# Access Compliance Report

## Public Rights-of-Way

| Intersection ID: 49135                  | Main Street: AMBER_LEIGH_WAY_DR | Cross Street: AMESBURY_HILL_DR          | Location: W            |
| ADA ID: 1A4AF3B18C31                    | Ramp Type: PerpDiag             | Initial Pass/Fail: Fail                 | Overall Compliance: No |

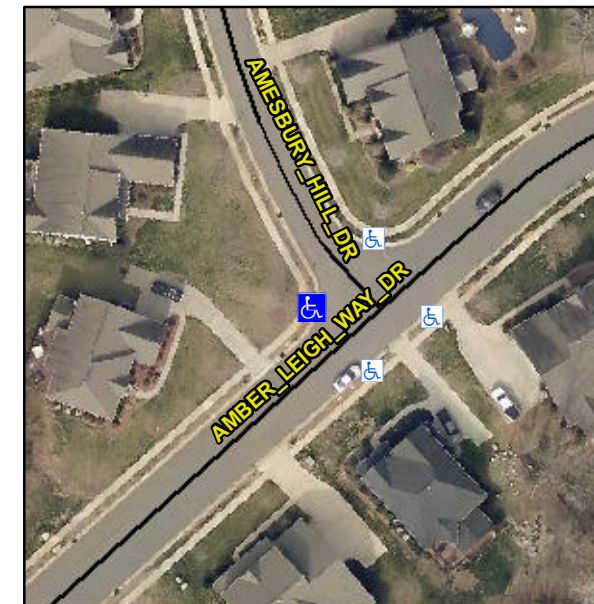
**R304.5.1, R304.2.2, R304.5.3**

| Compliance | Description           | Data  | Compliance | Description                 | Data  |
|------------|-----------------------|-------|------------|-----------------------------|-------|
| N/A        | Ramp Length (in)      | 44.0  | No         | Ramp Slope (%)              | 11.1  |
| No         | Ramp Width (in)       | 47.5  | No         | Ramp XSlope (%)             | 3.1   |

**Remove & Replace Curb Ramp With Two New Directional Ramps or Equivalent.**
